# Product Change Notification

Product Change Notification: P-24-026006

MOD IV Housings

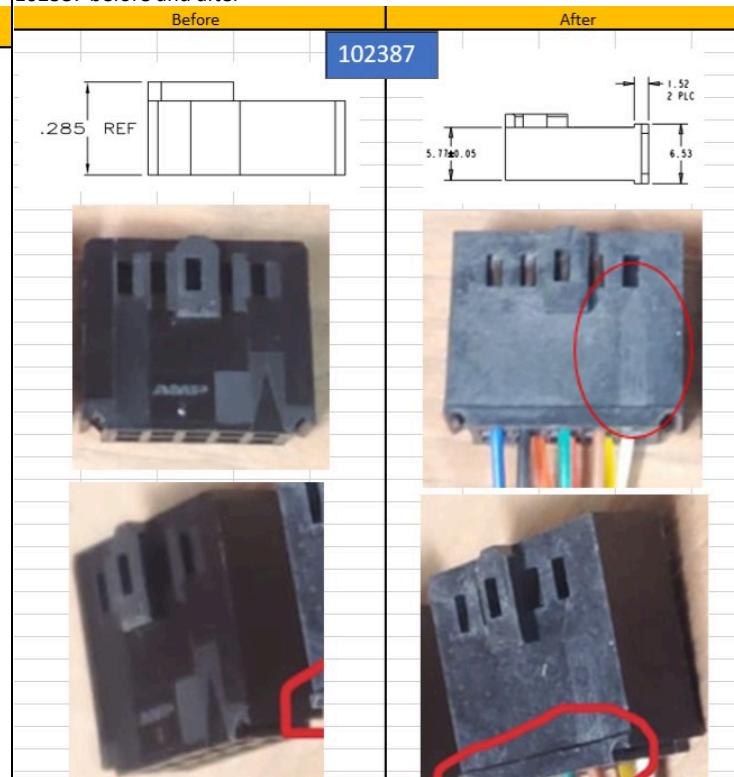
Change of resin, new "step" added and TE logo

87456 before and after

102387 before and after

Product improvement. Material changes from low temp to high temp resin and some product improvements were made (retooling)
